11th December 2015

Our Ref: 407.05238.00002  
Your Ref: P/DC/JMC/2015/01131/FUL

**RE: PLANNING APPLICATION REFERENCE: 2015/01131/FUL  
PROPOSED REMOVAL OF FILL MATERIAL, IMPORTATION OF INERT WASTES  
WITH THE PROGRESSIVE RESTORATION OF THE FORMER MINERAL  
WORKING AREAS ASSOCIATED WITH THE FORMER ELY BRICKWORKS**

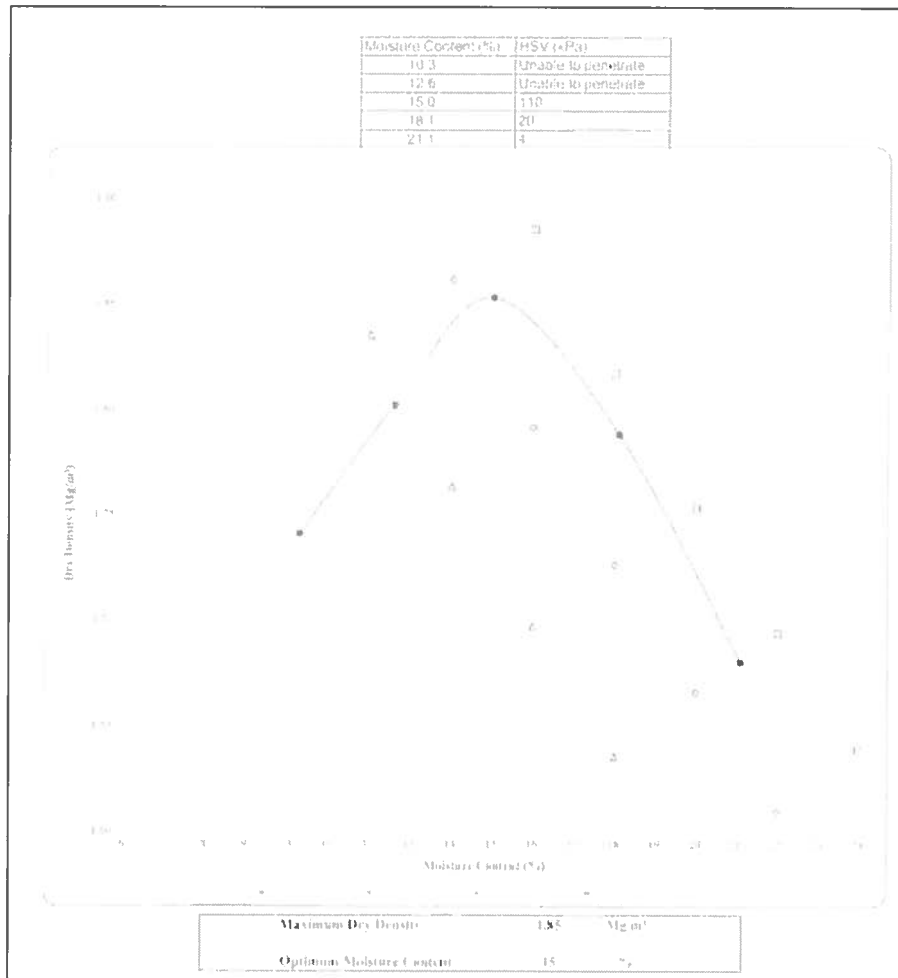
*"If this is a genuine restoration scheme rather than a landfill site for the disposal of inert waste, there should be no need to remove material from the site unless there are genuine geo-technical reasons for doing so. No Geo-technical assessment has been submitted demonstrating that any material has to be excavated and is of such a type that it cannot be incorporated into the restoration scheme.*

*Creating an extraction void with the specific intention of filling it with waste is a disposal operation. Remediating a piece of land utilising inert waste is on the other hand a recovery operation in terms of the waste hierarchy. As a disposal operation it is doubtful whether this development could be justified as it would conflict with Policy WAST2 of the UDP, but as a genuine recovery operation it may well be justified as it moves waste that would otherwise be disposed of one step up the waste hierarchy."*

It is considered unlikely, based on material test results undertaken prior to the submission of the application that the historically backfilled material represents an appropriate basal platform on which to commence the emplacement of restoration materials. The extraction of this material was not proposed to create void-space, but due to the properties of the backfilled material being inappropriate as a stable base for the restoration. In order to overcome this issue, it was proposed to remove the historically backfilled material down to original bedrock in order to create a geological barrier on the in-situ brick clay bedrock at the site. Essentially the floor level of the old quarry below the backfilled waste will form the base of the geological barrier.

The results show that the material is consistent with regard to the atterberg limits, clay content and low permeability, the soil also has a high silt content. The shear strength was tested at different moisture contents when establishing the optimum moisture content/ dry density curves (see figure above). It was found that the shear strength was very low (<20kPa) where moisture content was greater than 18%; two of the three samples (B1 and B2) had a moisture content greater than 18%. For context a good engineered fill would be expected to have a minimum shear strength of >50kPa.

The low shear strength, which is most likely due to the high silt content, would indicate that this material would not be a suitable platform for backfilling with inert waste due to the potential risk of failure. The investigation recommended that the backfill material should be excavated and the virgin material below the backfill should be exposed to ensure that a firm subgrade is achieved prior to construction of a low permeability geological barrier and subsequent backfilling with inert waste. It is anticipated that selected backfill soils will be suitable for construction of the barrier, particularly those at greater depths which would be expected to have lower moisture content and thus greater shear strength than the soils at the surface. The proposal to remove the historically backfilled material is therefore based on the material stability test results.
